# Colston Budd Rogers & Kafes Pty Ltd

Our Ref: TR/12161/mc

**RE: SOUTH AUSTRAL SHOPPING CENTRE  
RESPONSE TO TRAFFIC MATTERS**

1. As requested, we have reviewed the traffic matters raised in Council's RFI letter dated 11 March 2024. We prepared the Traffic Report<sup>1</sup> that was submitted with the development application.

**NOTE:**  
SKETCH PLAN ONLY. PROPERTY BOUNDARIES, UTILITIES, KERBLINES & DIMENSIONS ARE SUBJECT TO SURVEY AND FINAL DESIGN. TRAFFIC MEASURES PROPOSED IN THIS PLAN ARE CONCEPT ONLY AND ARE SUBJECT TO FINAL DESIGN BY CIVIL ENGINEERS.

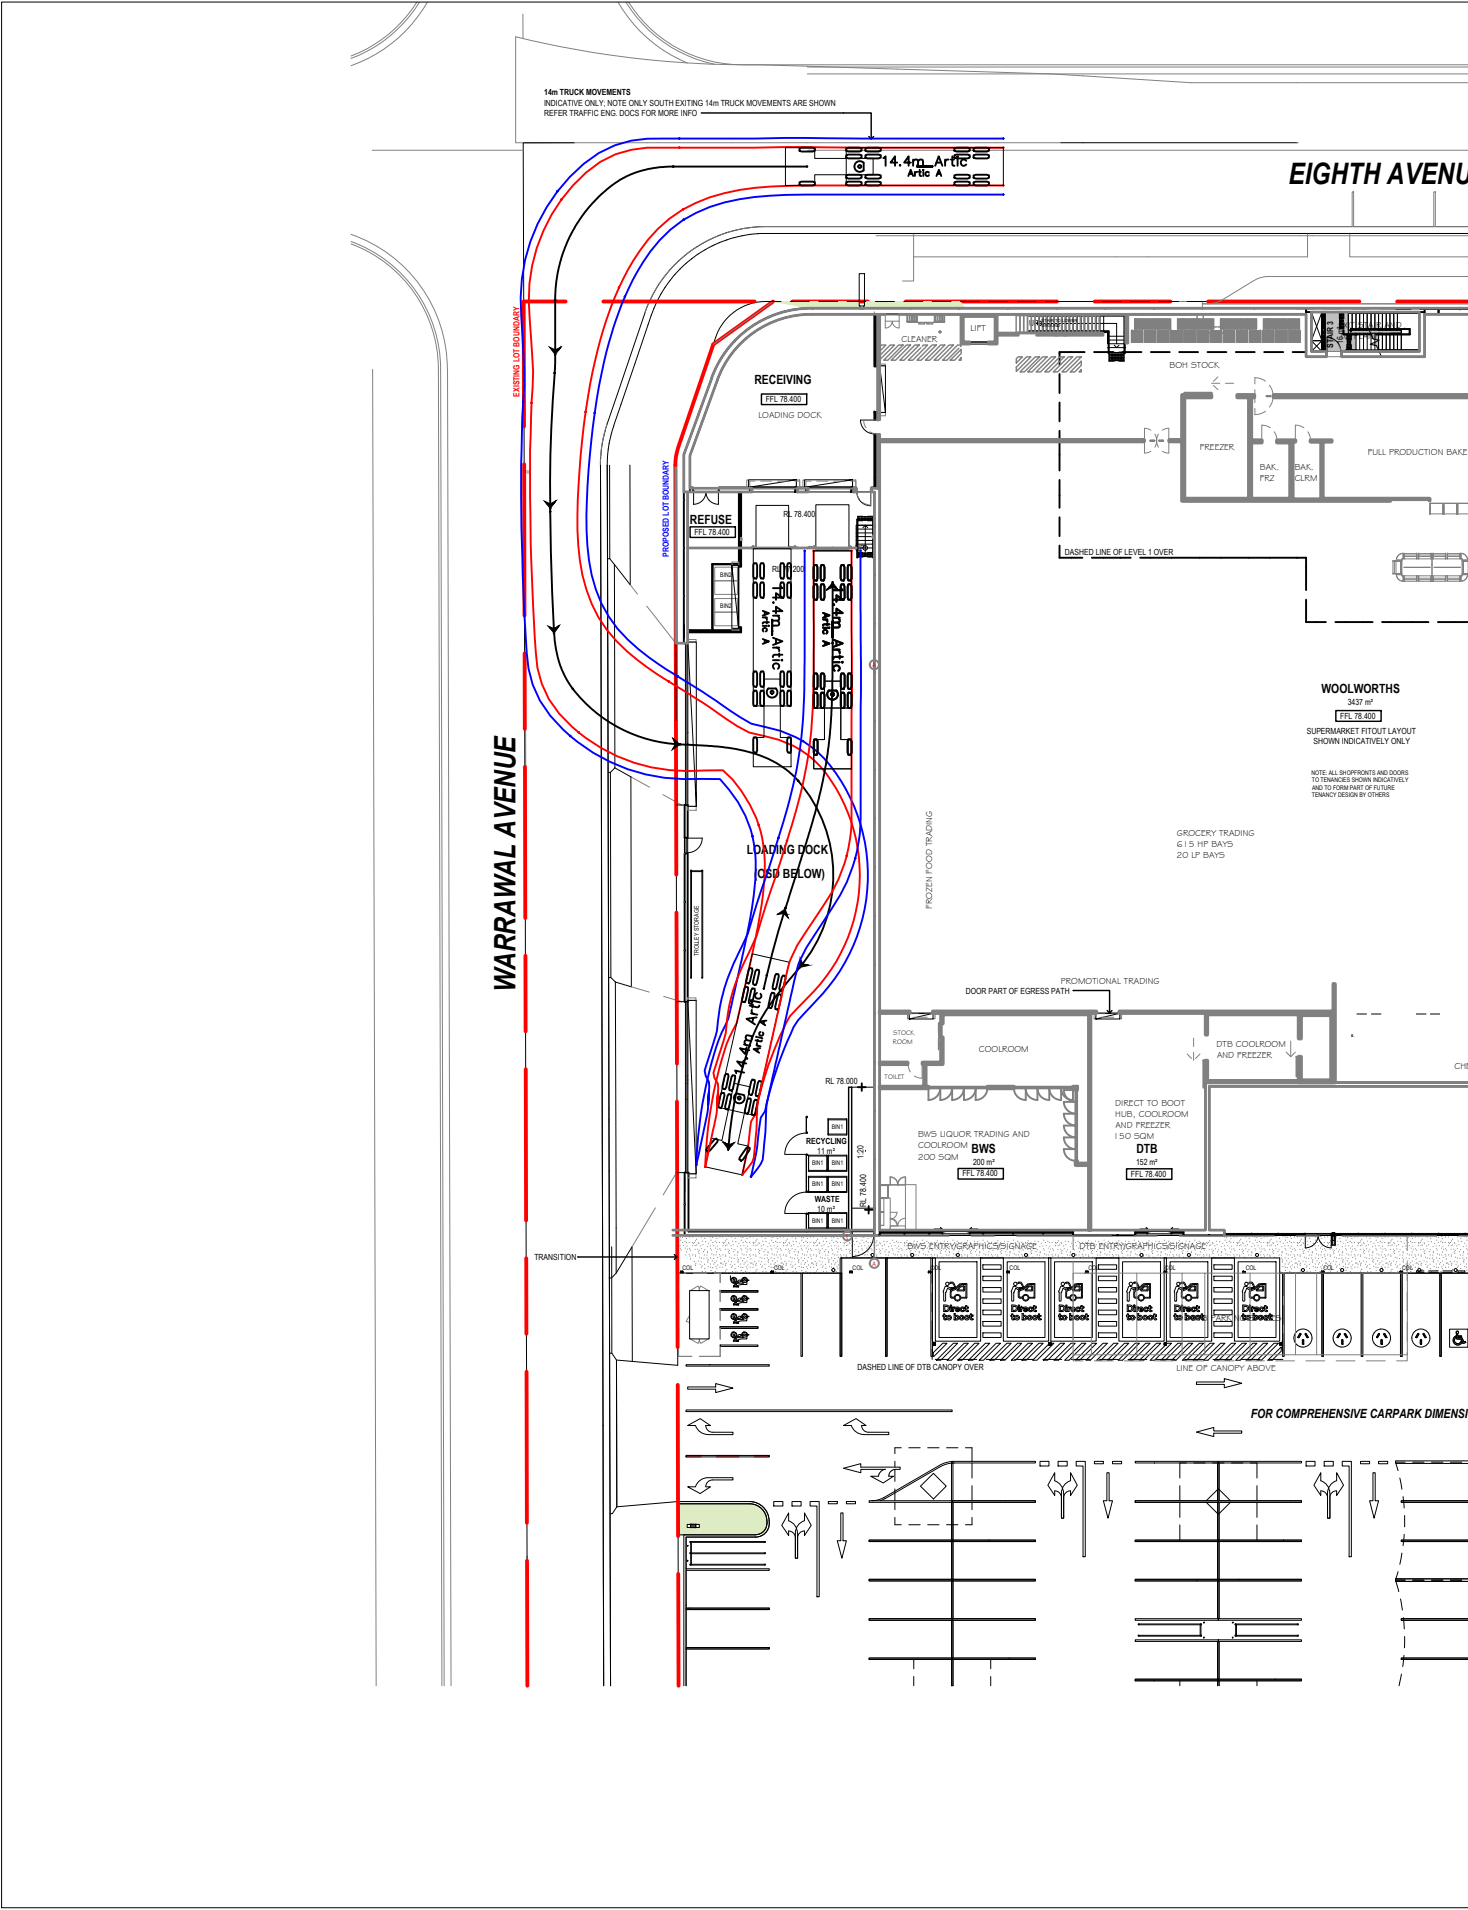
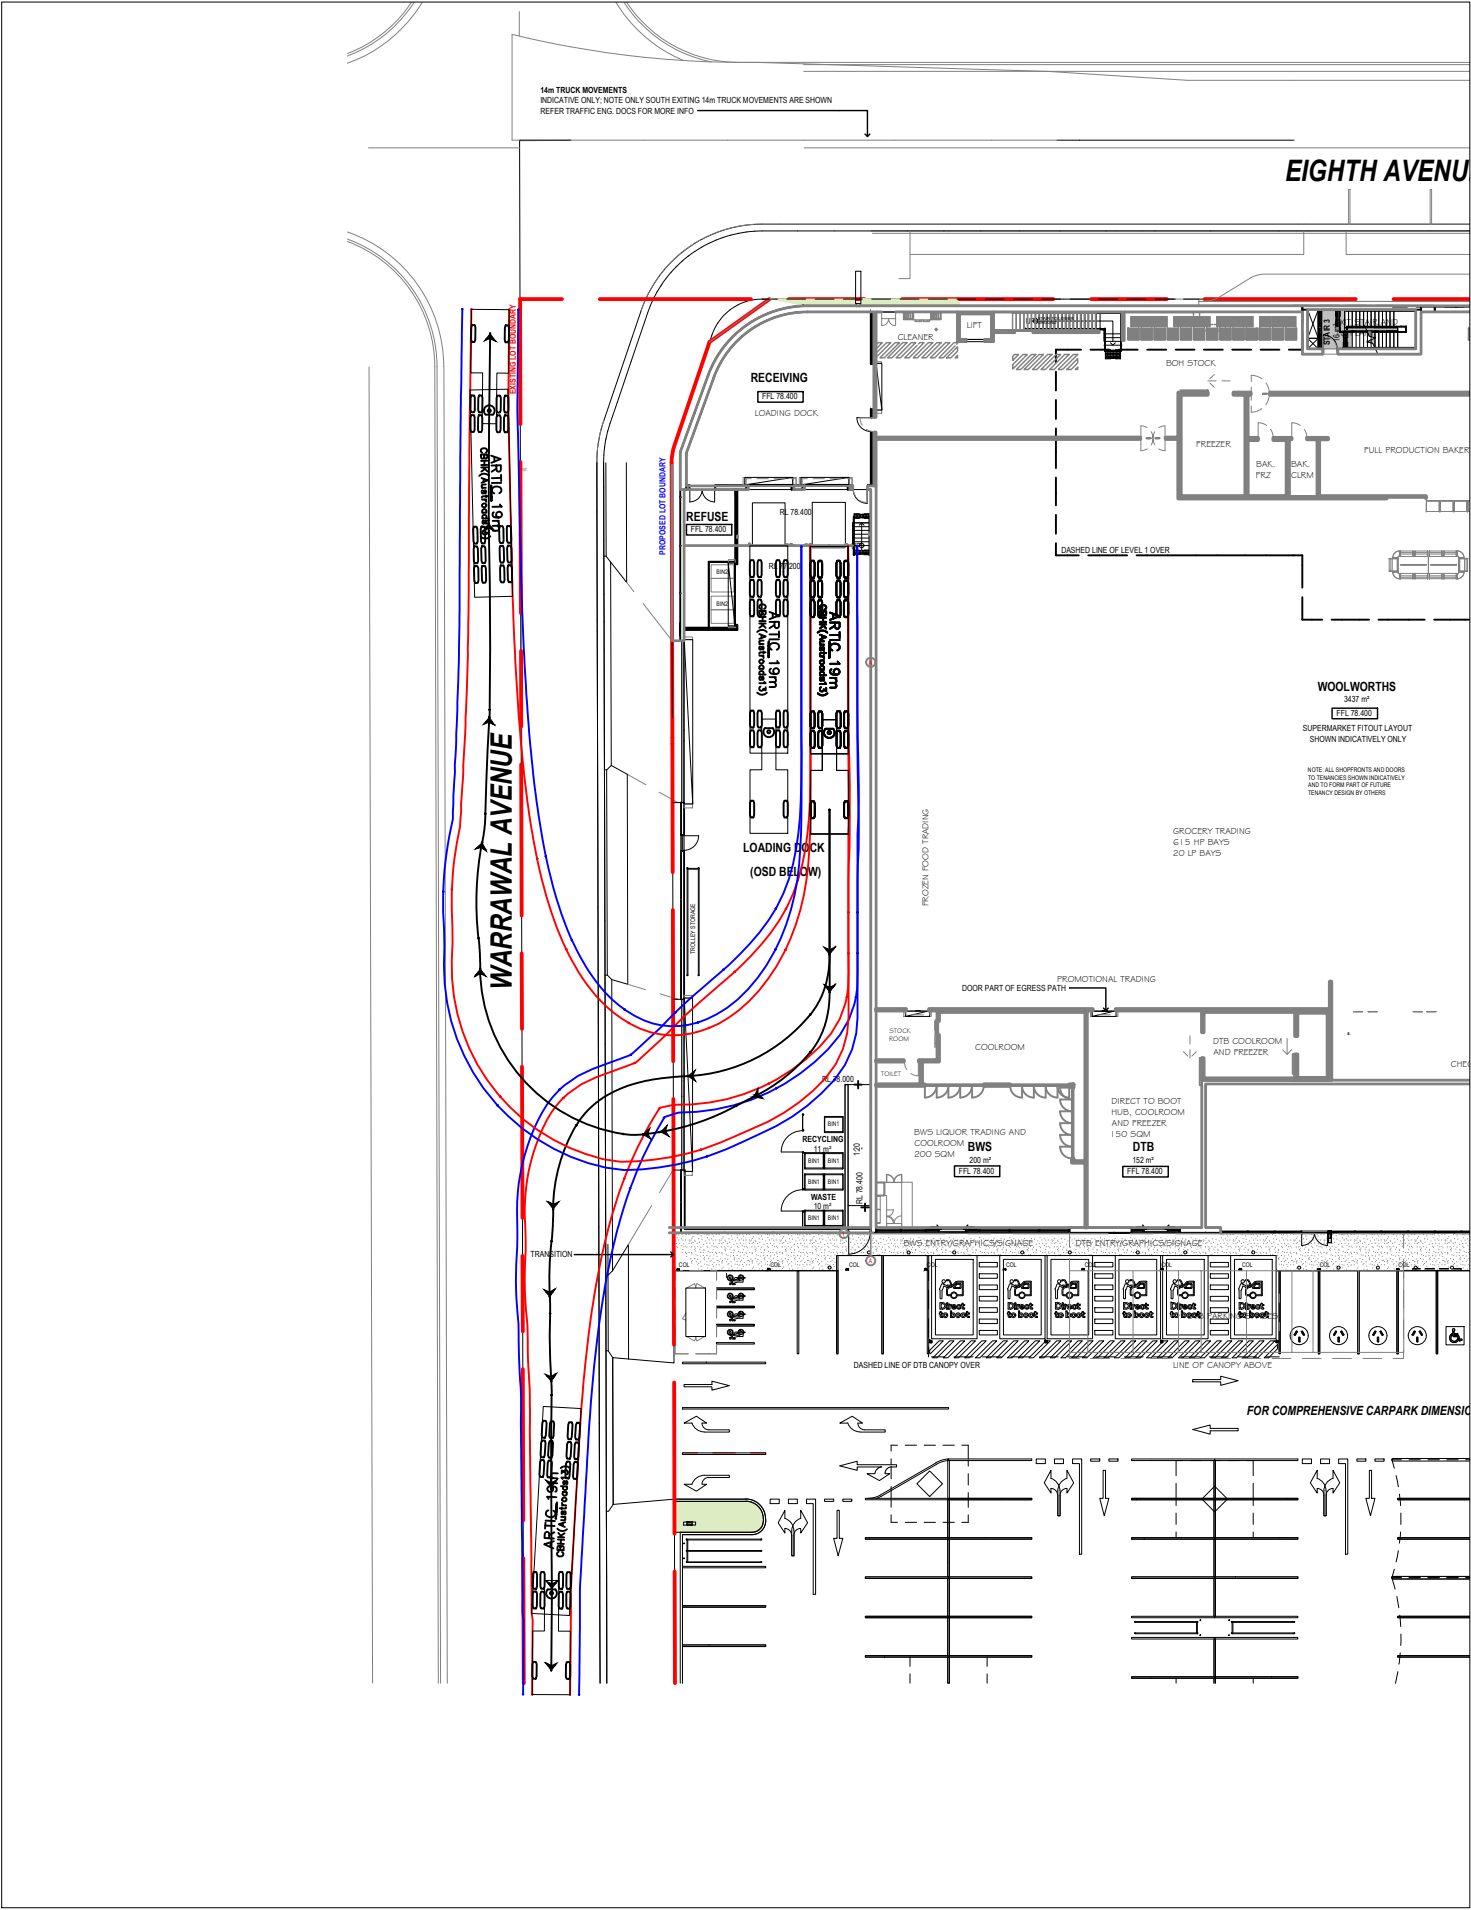
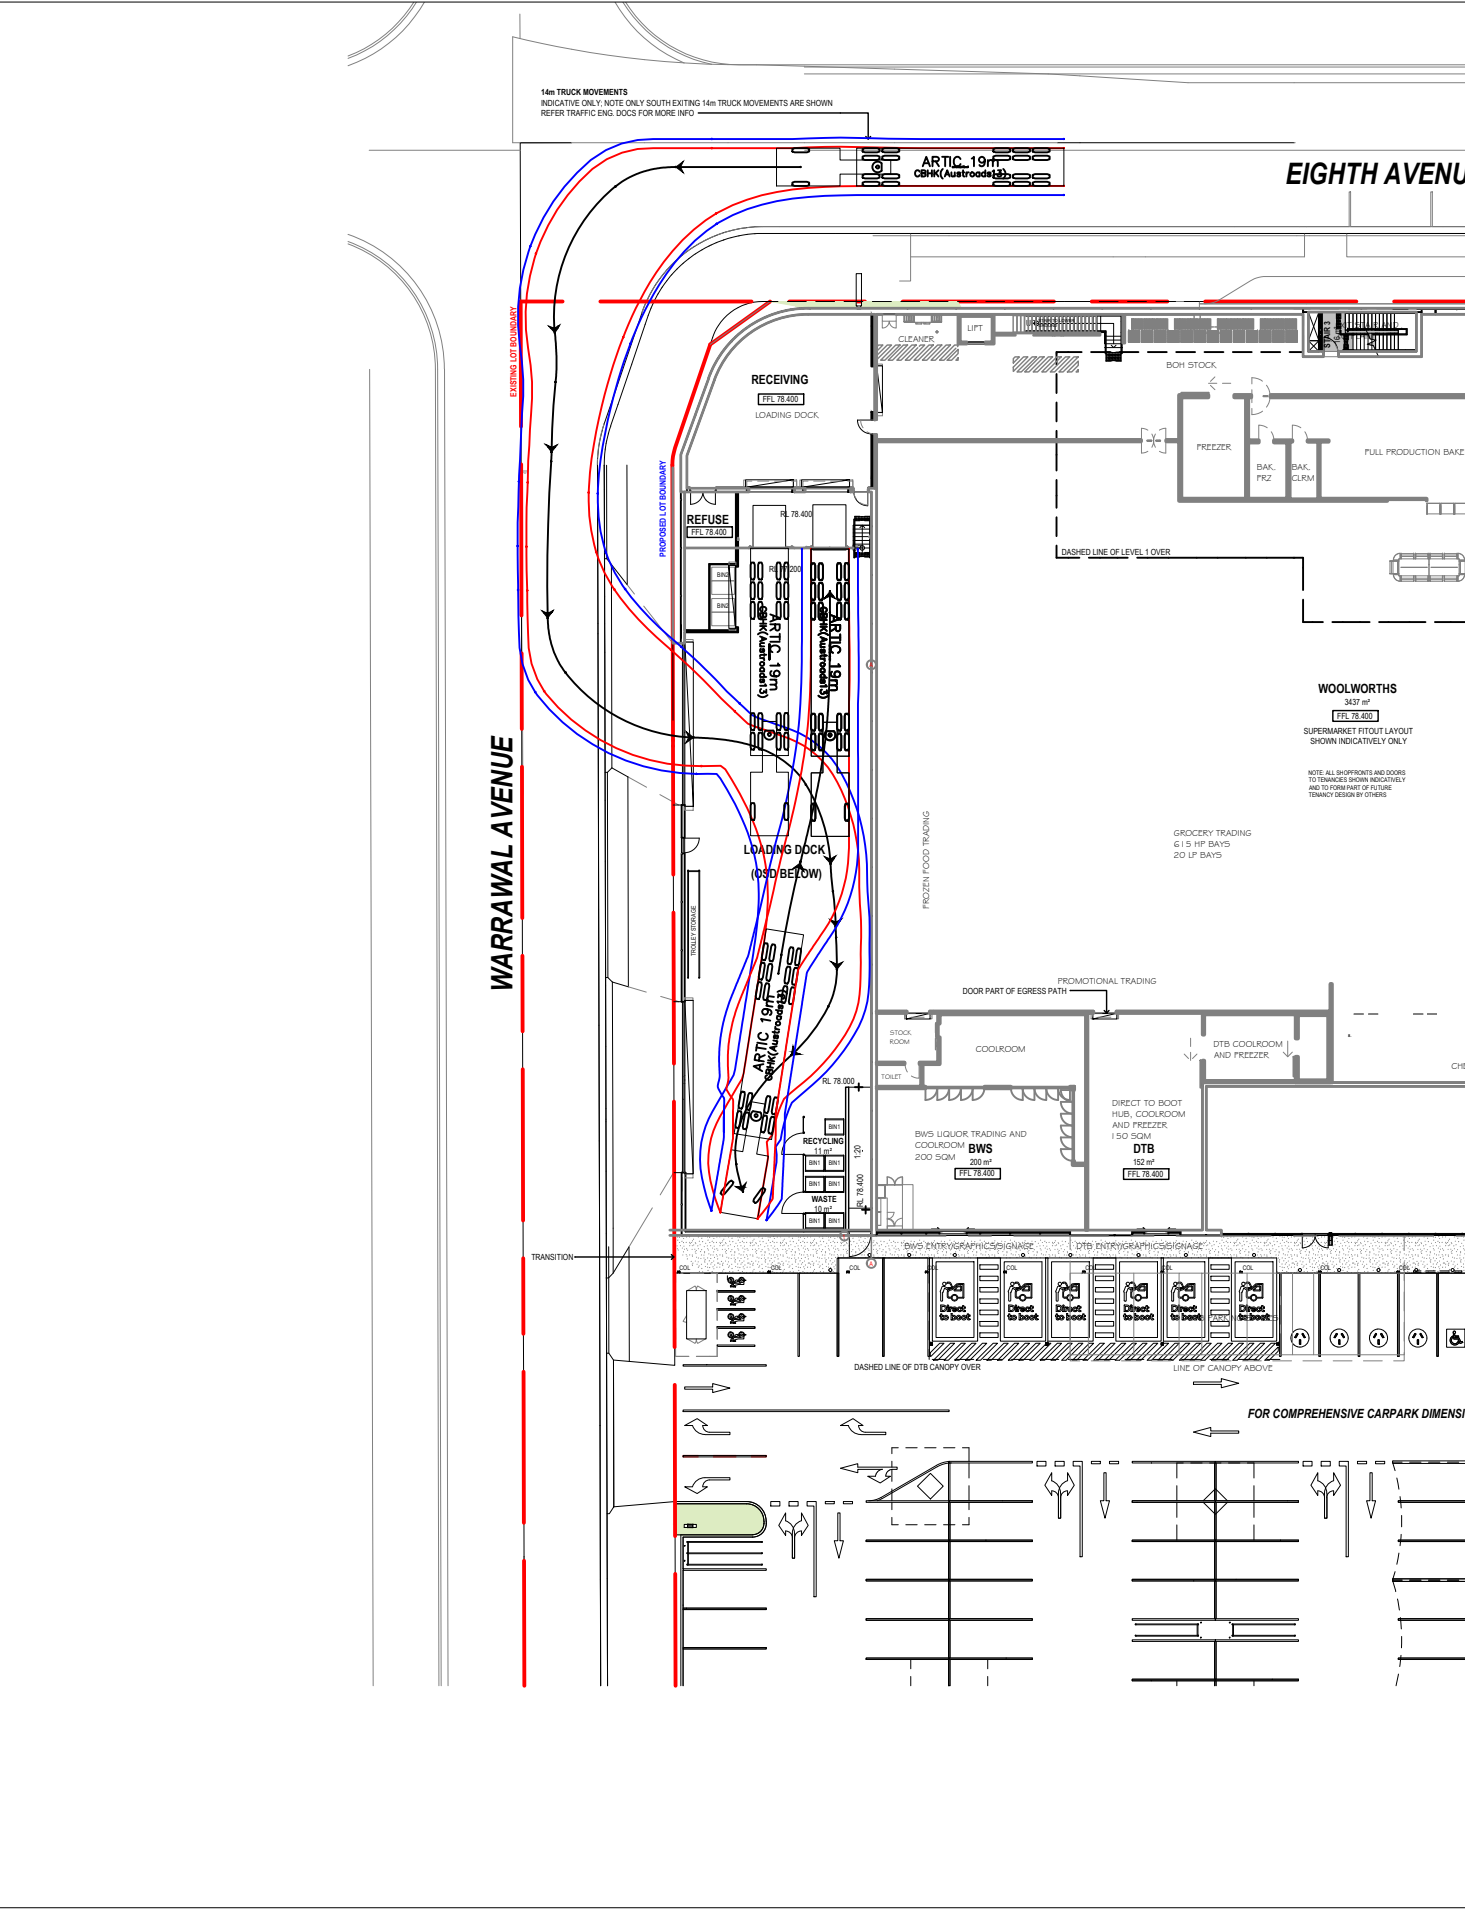
*The submitted Traffic Impact Assessment recommends that an additional two loading bays (6 metres long by 3 metres wide) are provided in the northeast corner of the car park. These bays will cater for vans and couriers servicing the specialty shops and commercial area. The submitted plans do not show where the additional loading bays would be. Amended plans and documentation must demonstrate that parking provision is not impeded by any additional loading bays.*

10. The amended plans prepared by CHC show minor modifications to the loading dock (new waste facility) and at-grade car park (provision of two loading bays (6 metres long x 3 metres wide) in the northeastern corner of car park (for vans and couriers) and relocation of the DTB spaces two spaces to the west). Updated vehicle swept paths are provided in Attachment A.

13. **Response:** Amended plans prepared by CHC show two additional loading bays in the northwestern corner of the car park (adjacent to the specialty retail tenancies).
